The new polarizer and diffuser accessory are attached to the In-Sight 7000 lens cover. They are secured in place with small hex screws (hex tool included with accessory). Upon removal of the accessory – you may notice scratches on the lens cover however this is a cosmetic issue and does not affect the IP67 rating.

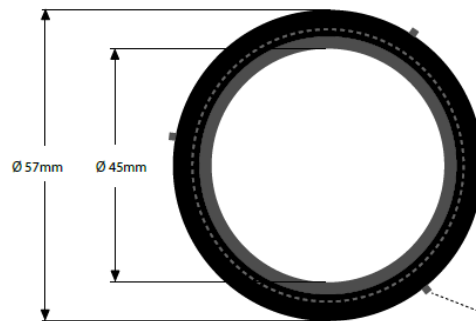
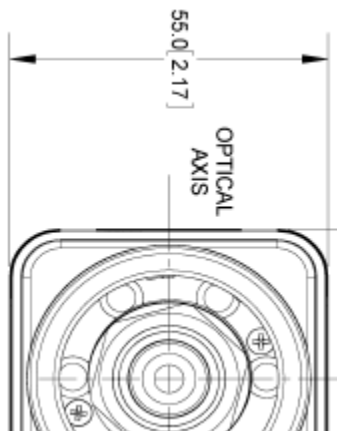
The diffuser and external polarizer piece are wider than the In-Sight 7000 cover by 2mm.

The body of the In-Sight 7000 is 55mm wide; the diffuser/polarizer is 57mm in diameter.
